**556, 558 Scarlett Road and 13 Chapman Road – Zoning By-law Amendment Application - Request for Direction Report**

<b>Date:</b>	October 30, 2008
<b>To:</b>	Etobicoke York Community Council
<b>From:</b>	Director, Community Planning, Etobicoke York District
<b>Wards:</b>	Ward 2 – Etobicoke North
<b>Reference Number:</b>	08 149633 WET 02 OZ

# Attachment 1: Site Plan

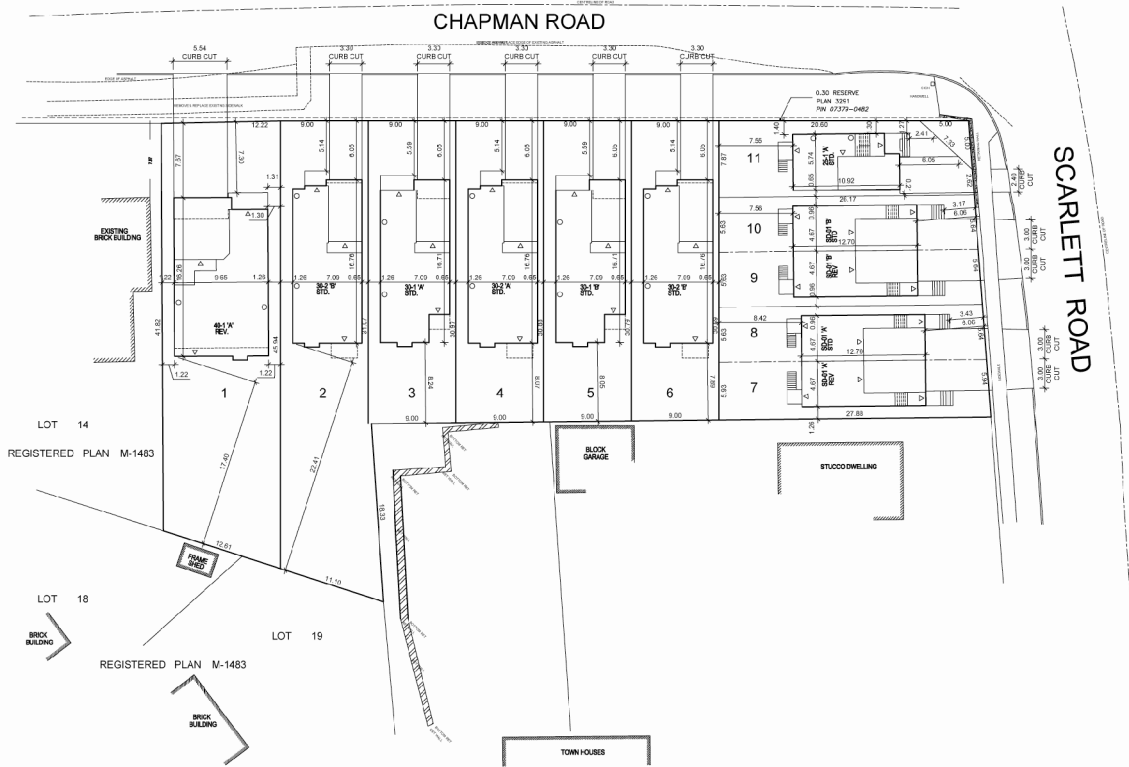
The topography of the site is proposed to be significantly altered with substantial regrading, filling, terracing and use of retaining walls to accommodate this development. In some areas, over 3 metres of landfill is required to accommodate the proposed dwellings whereas currently, a minimal grade difference exists with the Scarlett Road properties and the southerly adjacent lands. Extensive use of retaining walls approaching heights of up to 2.1 metres (6.9 feet) is proposed for Lots 1-4.

In an attempt to create a proper surface drainage system, 2 metre wide easements and/or restrictive covenants are required near/along the rear lot lines for Lots 2 to 11, thereby further limiting the use and enjoyment of the already uncharacteristically small rear yards. This concern can be alleviated through a development incorporating larger lot sizes.

- significant surface drainage originating from Lots 1 and 2 may warrant installation of a catchbasin on Lot 3

With the current proposal, Units 1 through 6 drain primarily to the rear of the lots. The surface drainage from these lots is being directed onto an infiltration trench at the rear of the lots. Any excess stormwater will be collected into a catchbasin located within Lot 7 and then be piped to the public storm sewer on Chapman Road. Lots 1 through 7 will therefore need to be encumbered by an easement for drainage. Lots 7 through 11 generally direct their surface drainage to the front of the lots. The icing of the Scarlett Road public sidewalk therefore remains a concern. The proposed grading for Lots 7 through 11 includes a terraced-down effect between lots and a dishing effect has been created in the rear yards which impacts on the usable portion of the already relatively small rear yards.

Whereas the grading proposal is an improvement over the previous one, and whereas the current proposal will function as designed, more could be done to improve the drainage and the usable portions of the rear yards. For example, an infiltration trench such as the one proposed for Lots 1 through 6 could be provided for Lots 7 through 11 in conjunction with a retaining wall along the entire rear lotline of Lots 7 through 11. Although a direct connection to the storm sewer is not permitted for residential development except in unusual circumstances, we recognize that the grading of this site is difficult and are prepared to accept storm water overflow entering the

Being the largest lots and having very steep slopes, a significant amount of surface drainage will originate from the proposed Lots 1 and 2. Installation of a catchbasin may be warranted in Lot 3, however a gravity fed connection to the Chapman Road storm sewer is doubtful. The applicant should investigate how/if the two existing catchbasins within the adjoining property near the rear of the proposed Lots 3 and 4 are connected to the public sewer. Should these catchbasins have connections through the development site to the Chapman Road storm sewer, this will adversely impact development of the site. Should these catchbasins be functioning successfully without connections to the public storm sewer, consideration should be given to the methodology and a similar installation be provided in the rear of Lot 3.

It is noted on the Landscape Plan that trees are to be planted in close proximity to the infiltration trench. Although the trees will assist in groundwater absorption, without protective measures the infiltration trench will be quickly rendered useless. The trench must therefore be protected by means of a root deflector to prevent the tree roots from penetrating the filter cloth and filling the trench voids.

In order to achieve this, staff envisions a proposal that employs a minimum of 12m lot frontages for a maximum total of 4 lots fronting onto Chapman Road. For the Scarlett Road frontage, staff would be prepared to consider a proposal for either two single family detached lots, each having a frontage of approximately 15 metres, or a total of 4 semi-detached units, each with an approximate frontage of 7.5 metres. This development scheme would yield a total of up to 8 new dwelling units on the lands. While still undersized in comparison to established community standards, these increases to the proposed lot sizes may still provide an opportunity to achieve appropriate building setbacks, open landscaped areas, lower and wider building types and masses, FSI standards, etc., leading to an overall scenario that more closely respects and reinforces the existing physical neighbourhood character. It may also provide an opportunity for tree preservation to occur, and perhaps this lot pattern may be amenable to a simplified grading and drainage scheme in response to the technical concerns raised.

proposed catchbasin and being discharged into the public storm sewer system. Further, in an effort to take pressure off putting all the drainage into one lot, we are prepared to accept two catchbasin outlets - one in the rear yard of Lot 6 collecting drainage from Lots 1 through 6, and discharging it to the Chapman Road storm sewer and the other in Lot 7 collecting drainage from Lots 11 to 7 in conjunction with an infiltration trench, concrete retaining wall, and easement along the rear lotline of Lots 11 through 7 discharging to the Scarlett Road storm sewer.
